**HISTORIC AND DESIGN REVIEW
COMPLIANCE AND TECHNICAL ADVISORY BOARD**

November 22, 2024

HDRC CASE NO: 2024-378
ADDRESS: 415 BELKNAP PLACE
LEGAL DESCRIPTION: NCB 1881 BLK 3 LOT E 80.78 OF 3
ZONING: R-4, H
CITY COUNCIL DIST.: 1
DISTRICT: Monte Vista Historic District
APPLICANT: Trevor Pollard
OWNER: Trevor Pollard/ALLESEE LORI & POLLARD TREVOR
TYPE OF WORK: Siding replacement
APPLICATION RECEIVED: October 28, 2024
60-DAY REVIEW: December 27, 2024
CASE MANAGER: Bryan Morales

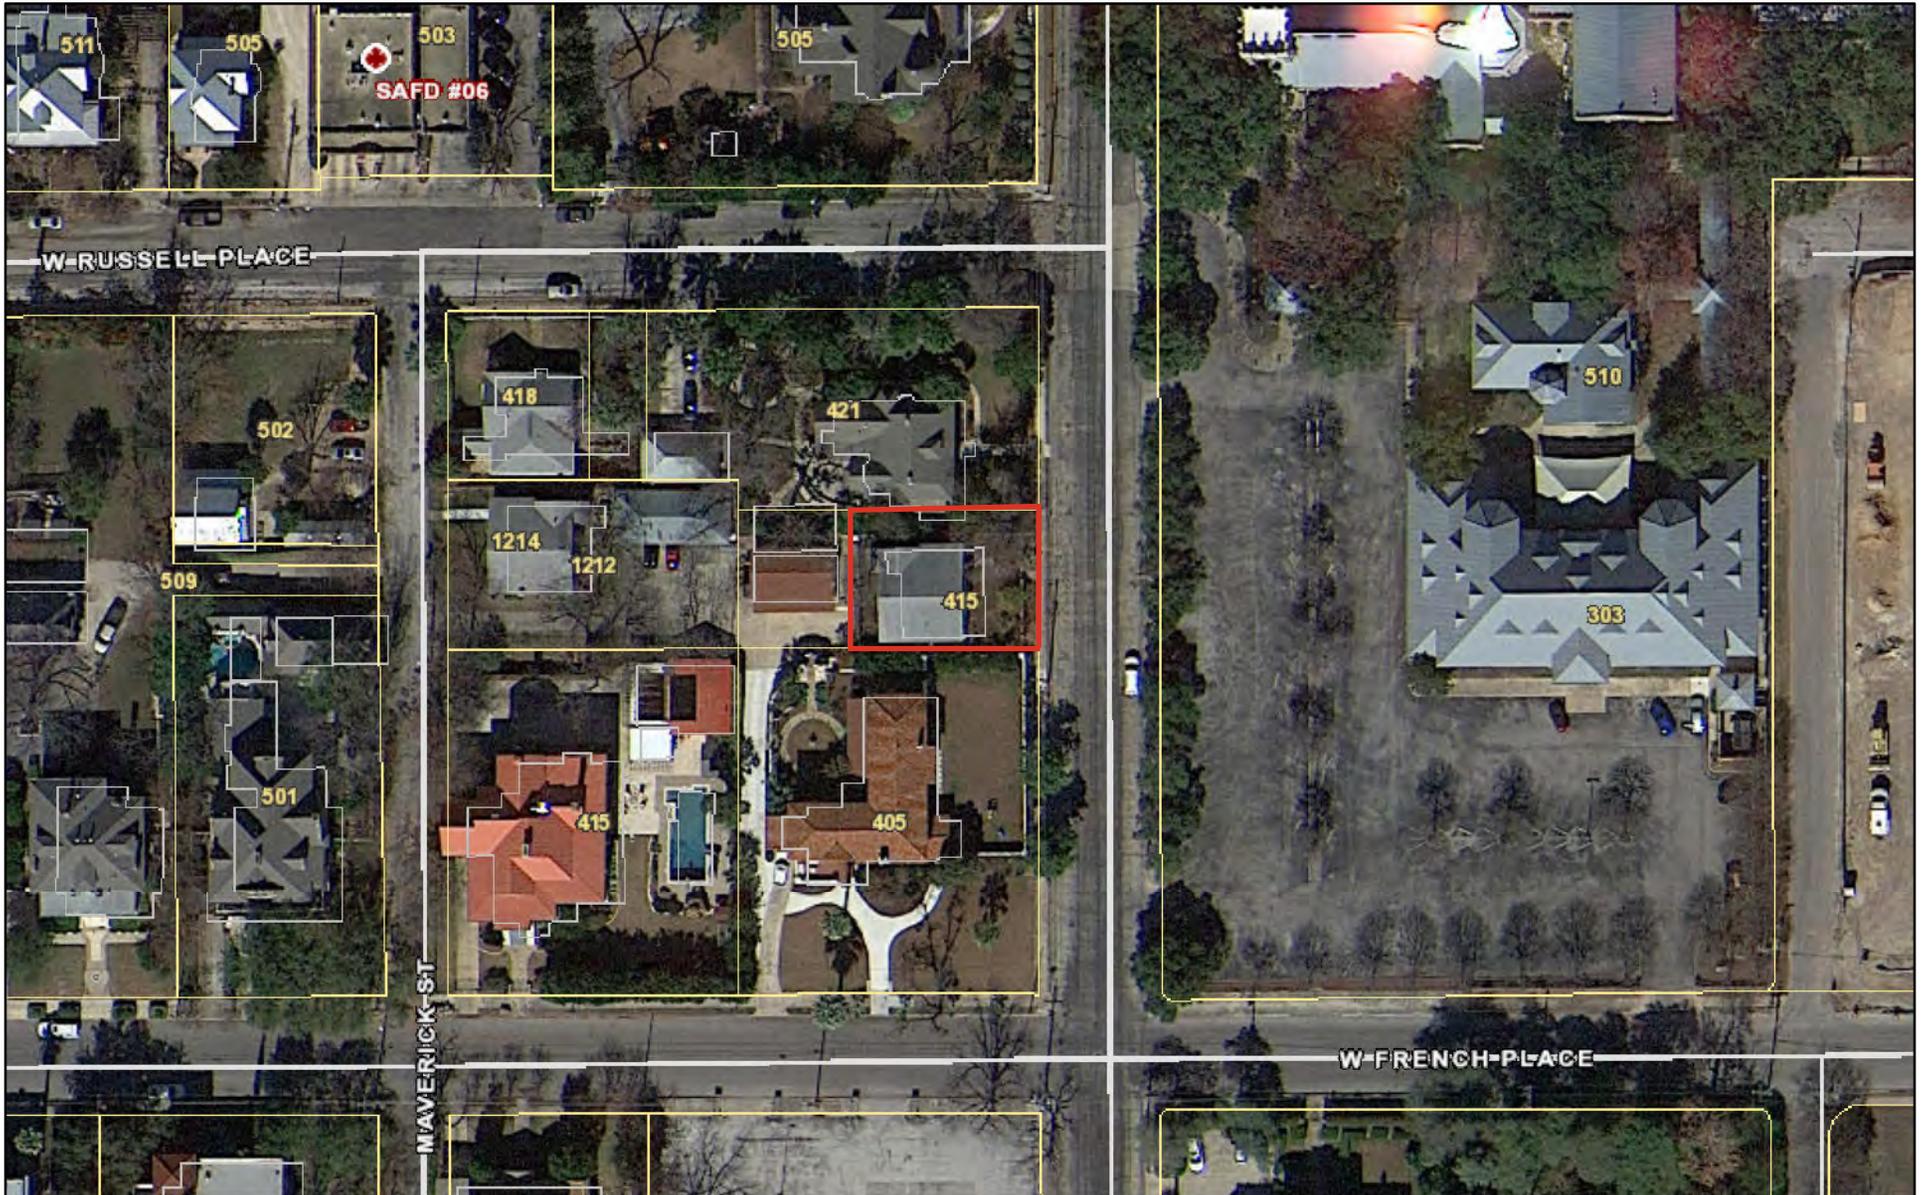
- a. The property located at 415 Belknap is a two-story structure featuring one-over-one wood windows, exposed rafter tails, and a front-facing gable roof. The structure first appears as a detached rear accessory for the structure located at 301 Belknap on the 1951 Sanborn Map. This property contributes to the Monte Vista Historic District.
- b. **SIDING REPLACEMENT** – The applicant is requesting approval to replace the existing wood drop siding located on the north, south, and west wall planes with fiber cement lap siding. The current siding is similar to a 105 siding profile which is commonly found on historic properties. Modern-day drop siding can be found at most lumber yards

but tends to lack durability and rot resistance when compared to old-growth wood siding. There is evidence that previous patching has occurred on this property, and it further appears that some of the replacement siding has already begun to deteriorate. In 2018, the siding on the front facade was replaced with approval and has experienced some warping and deterioration. According to the Guidelines, wholesale siding replacement should be avoided in favor of spot replacement and repair. Composite or artificial siding is typically not approved as a replacement to wood siding. The applicant has proposed a composite product this is visually similar to the existing drop siding. Staff finds that the applicant has begun to make a case for an alternative material, but it remains unclear how visually similar the proposed hardie product will be to the original.

Staff does not recommend approval at this time. Prior to approval, the applicant must demonstrate the following:

- i. That the existing wood siding is deteriorated to a point which would warrant wholesale replacement over the recommend spot treatment; and
- ii. That the proposed hardie product will be visually similar to the historic wood siding profile to a point which would be indistinguishable from the right of way.
